Portland General Electric Company

Trojan Nuclear Plant
Docket 50-344
License NPF-1

ATTACHMENT 1

Request 3.2.2 Cable Tray Tests (Train B Switchgear Room)

SKETCH NO. 2

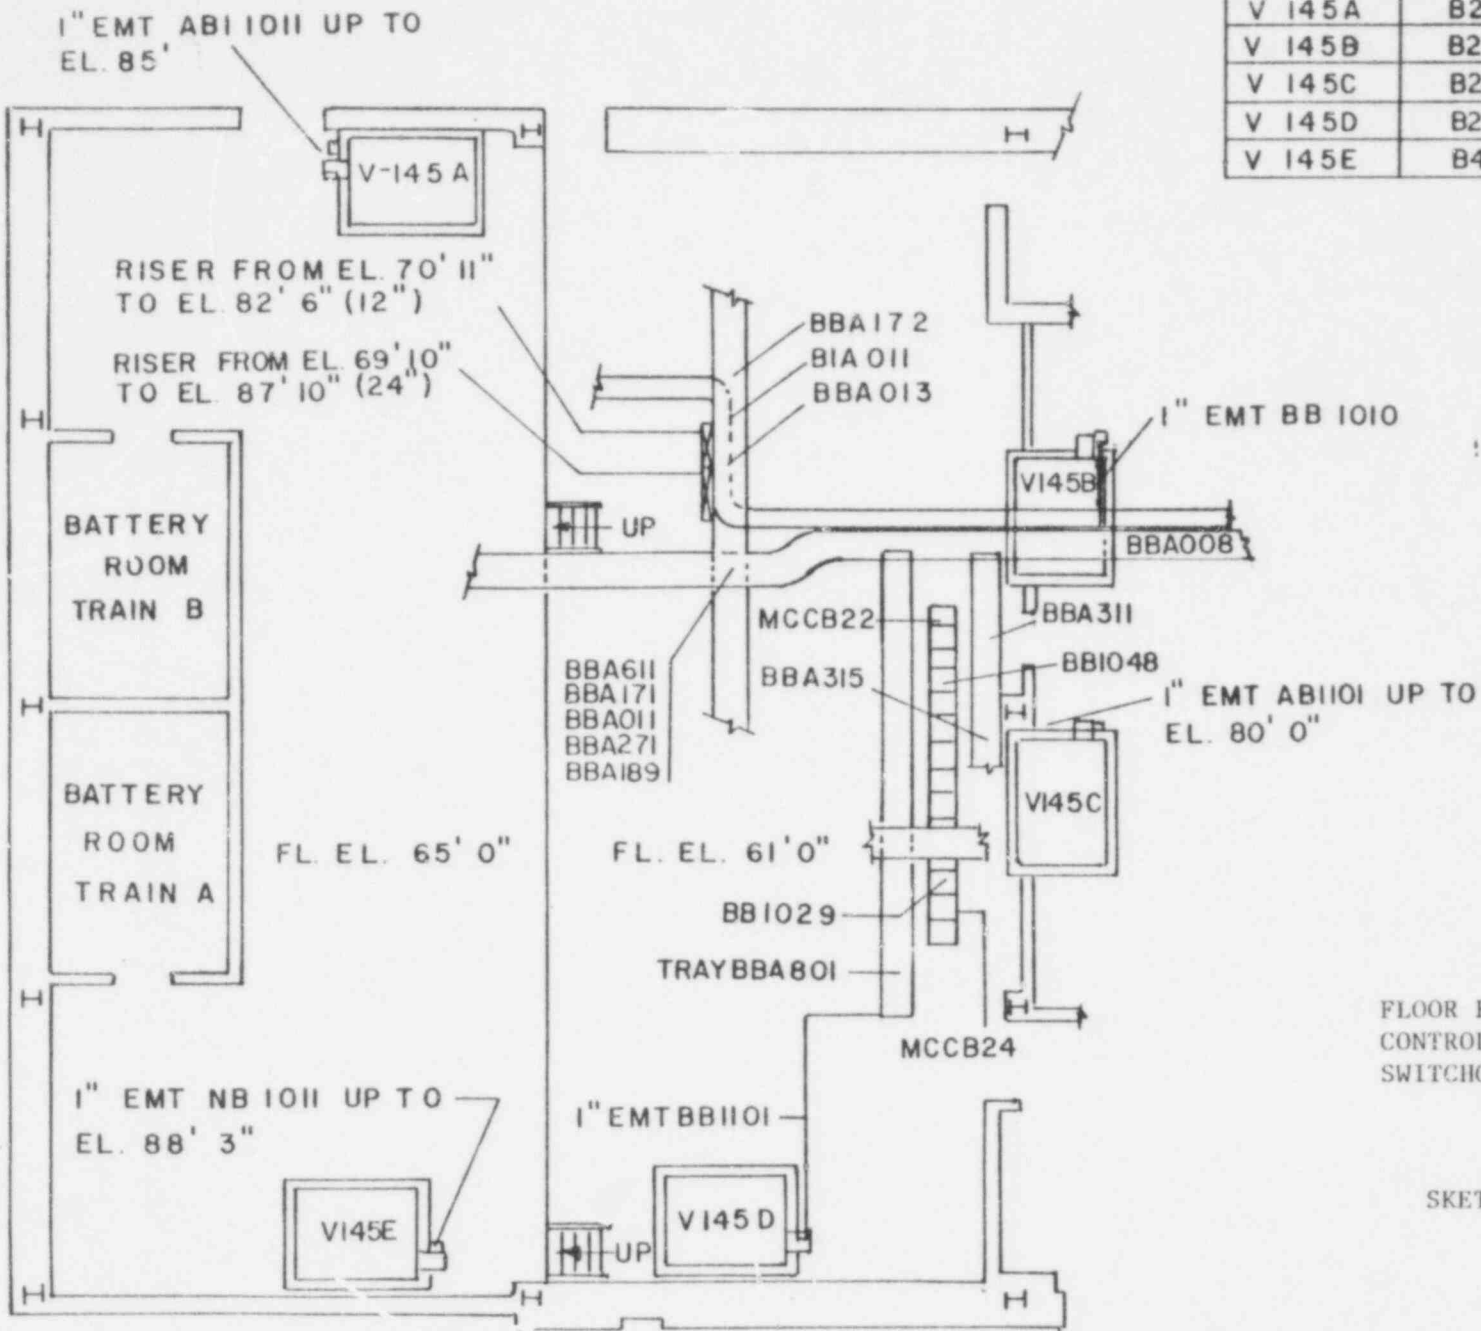
The PGE letter of January 9, 1979 indicates that adequate test data is available in lieu of performing additional tests to obtain information related to switchgear room fire protection. PGE in 1012 (Page C-50) indicates that the results of the test would be used in performing an analysis to show the adequacy of the air recirculation units in the safety train B switchgear room to remove the energy generated by a fire. Identify when the results of this analysis will be provided using the available test data. This analysis should consider maximum temperatures that train A equipment in this room can withstand without malfunction in addition to the maximum allowable cable temperature identified in PGE 1012, Pages C-49 and C-50.

PGE has performed a thermal analysis to show the adequacy of the air recirculation units in the safety train B switchgear room to remove the heat generated by a postulated fire. The analysis has been done for the most severe case of heat generation, due to a fire in the most concentrated cable tray arrangement. This arrangement is shown on the attached Sketch 1. The arrangement of the air coolers with respect to the subject cable tray is shown on the attached Sketch 2. It is judged that none of the air coolers would be affected by the postulated fire.
